Agenda Item	6.3
Report	PLS
No	013/16

15/04554/FUL: The Highland Council Inverness Museum and Art Gallery, Castle Wynd, Inverness, IV2 3EB

Description: Overcladding and external lighting

Inverness Museum & Art Gallery: Re-clad

Proposed West Elevation

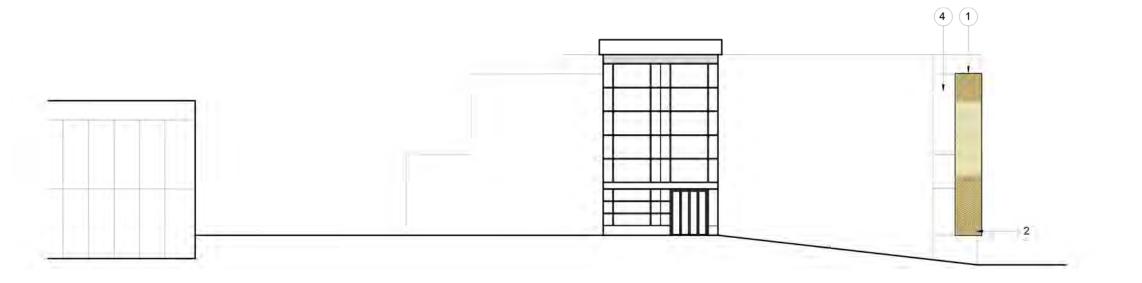
The Panel expressed a preference for the original, more abstracted concept. They did however have concerns about the west elevation which was originally blank. The proposals as submitted resolve this by realigning the pattern to provide sufficient visual interest on all sides of the building together with a richer and more varied pattern of perforations and surface finishes.
